DOE TESTIMONY TO EPA

May 12, 1983, Hearing

**COMPARISON OF CALCULATED
CURIE RELEASES TO EPA LIMIT FOR AM-241**

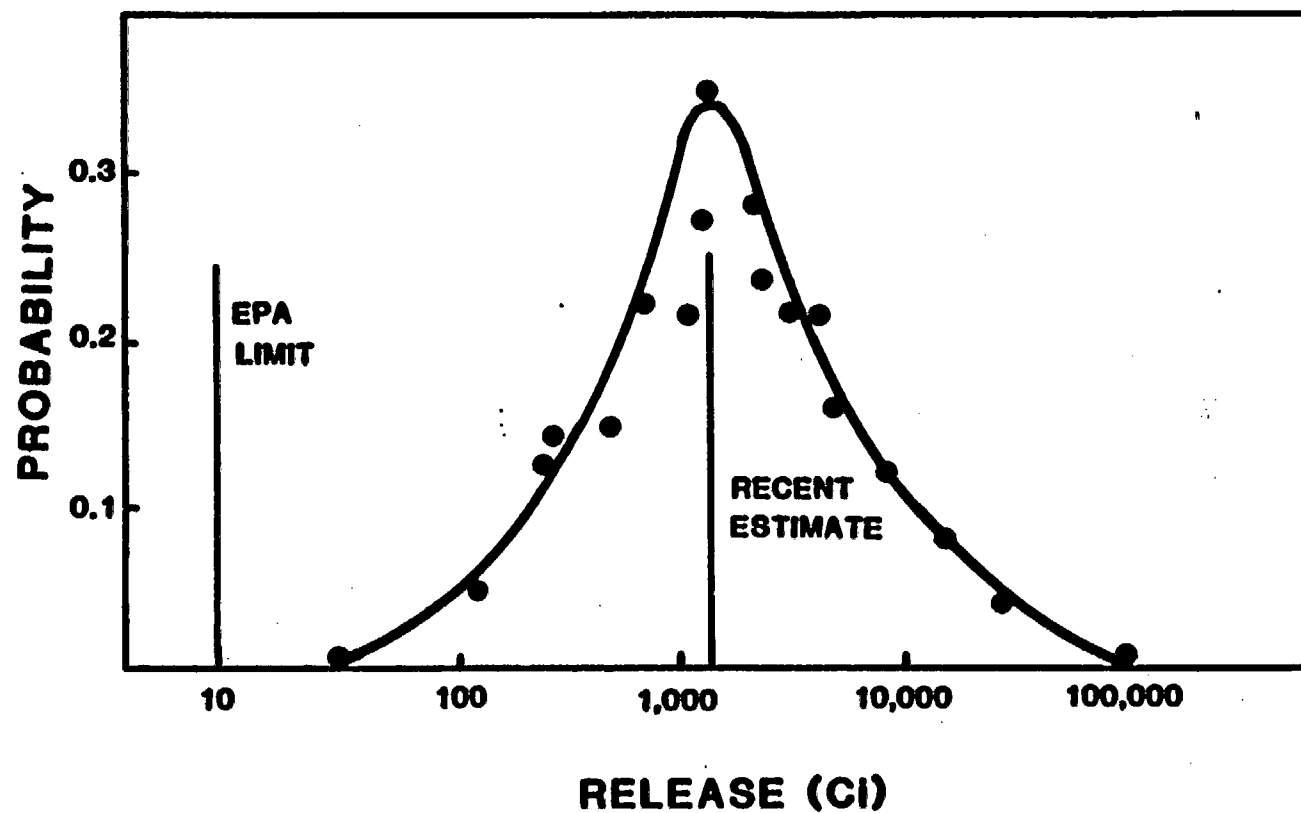
This figure (viewgraph) illustrates these points. The EPA curie release limit for the Am-241 isotope is shown on the left side of the figure. Recent estimates using a detailed and more complex model estimated the release limit to be over a factor of 100 greater than that calculated by EPA for the same assumed health effect. In addition, the spread in the estimated release limits extends three orders of magnitude. The proposed EPA limit for Am-241 does not even fall within the range of curie releases that would take into consideration the variability of data in a generic sense. For most other nuclides results are similar to a greater or lesser degree.

In summary there were substantial and compounded conservatisms used in deriving the EPA release limits. However, if DOE is required to further compound these conservatisms during the licensing process, conclusive demonstration of compliance may not be possible. In light of this we encourage EPA to reconsider the limits set in Table 2.
